Project	IEEE 802.16 Broadband Wireless Access Working Group < http://ieee802.org/16 >	
Title	Comments on the system reference model of SDD	
Date Submitted	2008-03-10	
Source(s)	Kanchei (Ken) Loa, Yung-Ting Lee, Youn-Tai Lee, Hua-Chiang Yin, Yi-Hsueh Tsai, Chun-Yen Hsu, Tsung-Yu Tsai, Yi-Ting Lin, Chih-Wei Su, Shiann-Tsong Sheu, Yih Guang Jan, Yang-Han Lee, Ming-Hsueh Chuang, Hsien-Wei Tseng Institute for Information Industry 7F, No. 133, Sec. 4, Minsheng E. Rd., Taipei City 105, Taiwan	Voice: +886-2-66000100 E-mail: loa@iii.org.tw * < http://standards.ieee.org/faqs/affiliationFAQ.html >
Re:	IEEE 802.16m-08/005- Call for Contributions on Project 802.16m System Description Document (SDD) Topic: Comments on IEEE 802.16m-08/003	
Abstract	This contribution proposes modifications to 16m system reference model to enable Management/Control plane in the relay station.	
Purpose	For discussion and approval by IEEE 802.16 Working Group

Comments on the reference model of SDD

Figure 3 System Reference Model

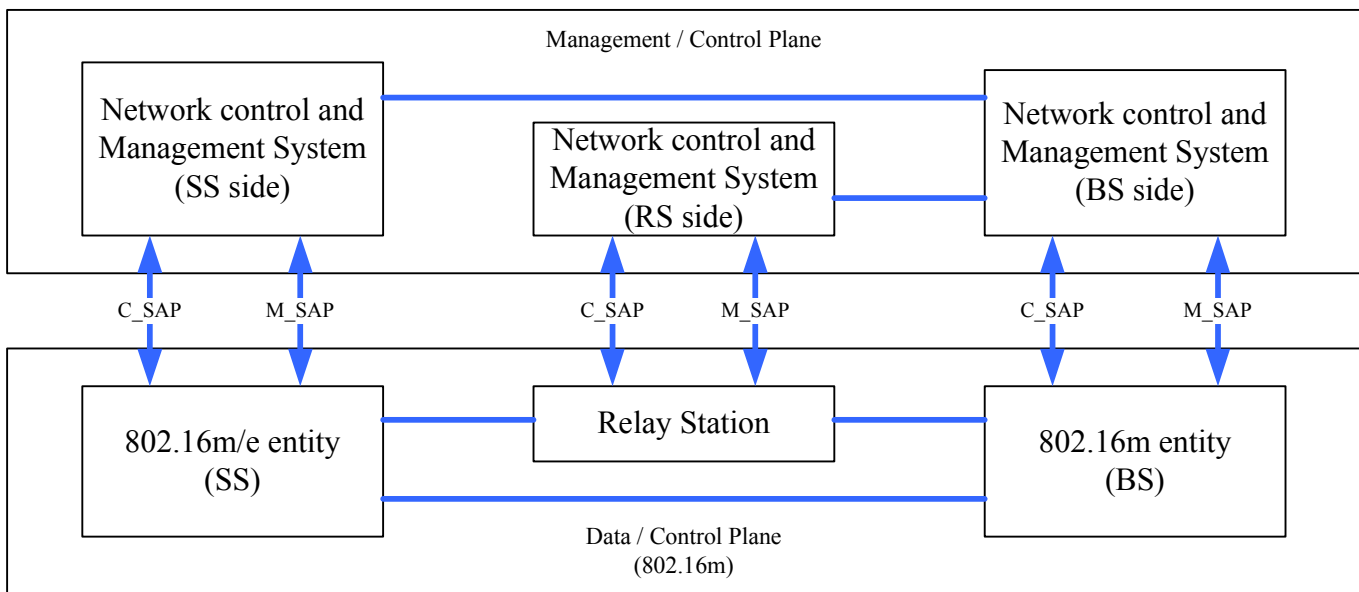
In the IEEE 802.16m system reference model of IEEE 802.16m SDD (IEEE 802.16m-08/003), the relay station is included in the Data/Control plane. However, the relay station (if present) is a critical component in 16m network infrastructure. Therefore, it shall be included in the Management/Control plane.

This contribution proposes modifications to 16m system reference model to enable Management/Control plane in the relay station. In order to facilitate the incorporation of this proposal into SDD, specific changes to SDD are listed below.

[Modify the following text and Figure 3 in Line 4, Page 8 as indicated:]

A simplified reference model for 802.16 network is shown in Figure 3. An 802.16m/e entity is the logical entity in a SS, RS or BS that comprises the PHY and MAC layers of the data/control plane. The Network Control and Management functions provide various control and management functions (including AAA, security, mobility, radio resource management, service flow management, paging and idle mode, MBS, location based services, MIH function, SS management, network management, regulatory services, multi-RAT interworking, etc.) and resides in **both** MS, RS and BS. A set of SAPs provide interfaces between them and 802.16m entities.
